**MUNICIPALITY OF THE COUNTY OF ANTIGONISH – NET ZERO BUILDINGS –
SOLAR PROJECT 22-82-C**

Addendum No. 3
Municipality of the County of Antigonish
Net Zero Buildings – Solar Project
Project No. 22-82-C

Schematic blocking detail for solar panel engineer to consider within shop drawing packages (below).

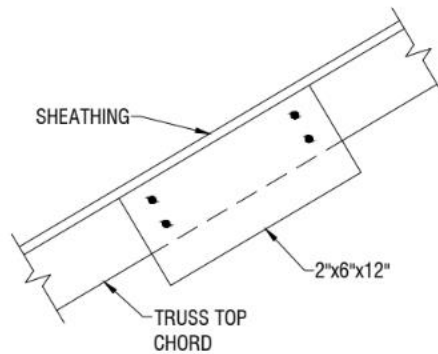
- Maximum solar panel and corresponding rail system weight not to exceed 3.5psf. This system is to be flush mounted to roof (to match existing roof slope).
- Rail connectors to be fastened to blocking mounted to the side of the existing truss top chord, shown schematically.
